UNITED STATES PATENT AND TRADEMARK OFFICE

APPLICATION NO.	FILING DATE	FIRST NAMED INVENTOR	ATTORNEY DOCKET NO.	CONFIRMATION NO.
10/055,083	01/25/2002	Terry Chou	12675 B	8107

Office Action Summary

DETAILED ACTION

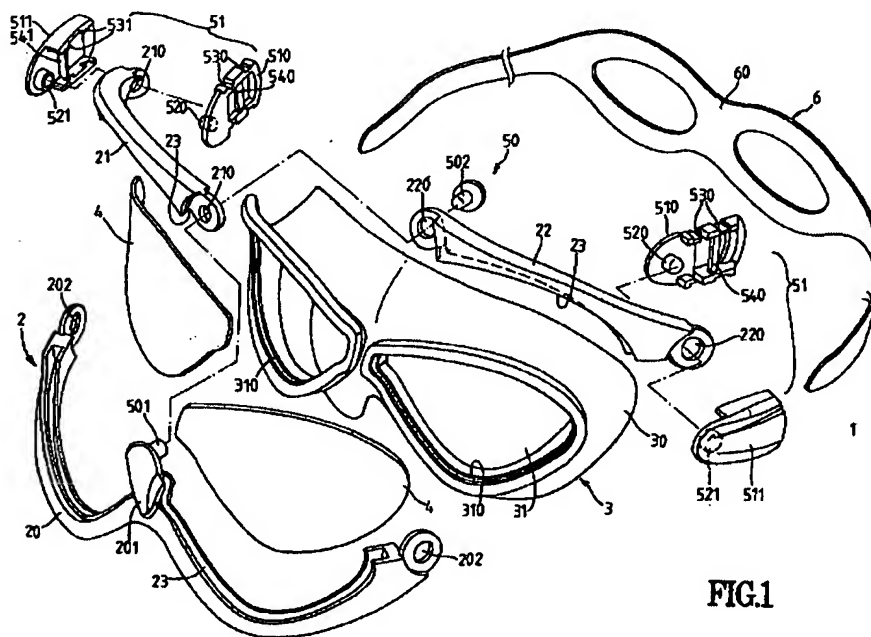
3. Claims 1, 8-10, 17 and 18 are rejected under 35 U.S.C. 102(e) as being anticipated by Chiang (U.S. 6,276,794).

Chiang discloses a lens/frame assembly for swimming goggles having a frame 2 made of a rigid material with slight flexibility and a lens holding compartment 23 having a bridge portion (see figure below) in the middle thereof. The bridge portion has an upper wall and a lower wall. Two lenses 4 are tightly received in the lens-holding compartment 23 of the frame 2. A connecting block 201 is securely received in the bridge portion of the lens-holding compartment 23 and securely mounted to the frame 2 to thereby securely retain the lenses 4 in place. The connecting block 201 connects the upper wall and the lower wall of the bridge portion.

With regard to claims 8 and 17, the bridge portion of the frame 2 comprises two engaging pieces 502 respectively formed on an upper wall and a lower wall of the bridge portion. Each engaging piece 502 includes a peg, the connecting

block comprises two engaging holes (see figure above) and each peg 502 extends through an associated one of the engaging holes of the connecting plate 201.

With regard to claims 9 and 18, the connecting plate 201 is securely attached between the lenses 4.

Furthermore, the swimming goggles include a strap 6 and padding members 30 that engages the lenses 4. The lenses 4 have flanges that are tightly received within the holding compartment 23.
